## Successive Conversion of BPW air bag beams for ECO Air

75162201e  
AM08 / 2022  
25.05.2022

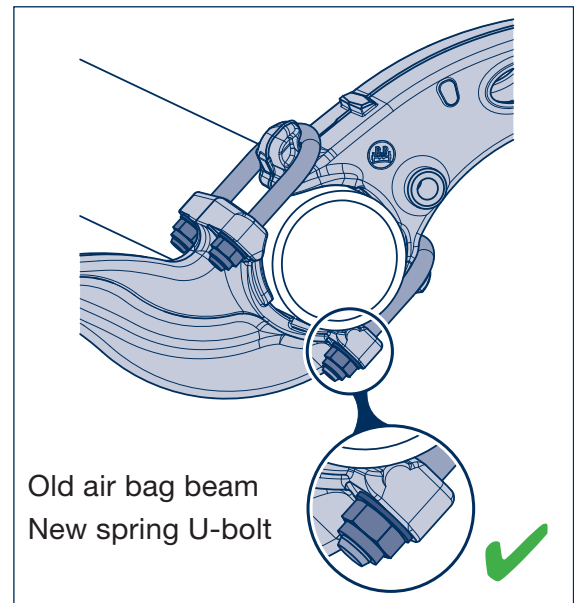
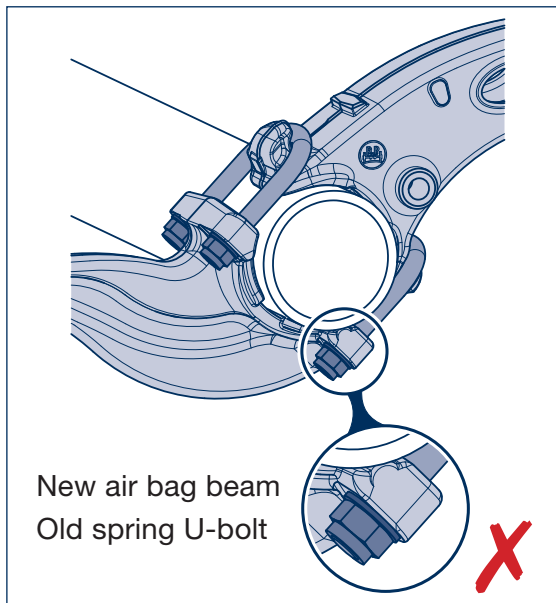
As an additional step in the current product enhancement process, the air bag beams will be thickened up by 5 mm at the drilling area. This version will be gradually introduced from Q2/2022.

Please note: The new generation of air bag beams should only be assembled by using the new spring U-bolts that have been extended by 5 mm (09.801.09.45.0). Assembling the new air bag beams with the old spring U-bolts (09.801.09.03.0) is not permitted. To prevent vehicle breakdown, we recommend not to mix possible existing Components on stock.
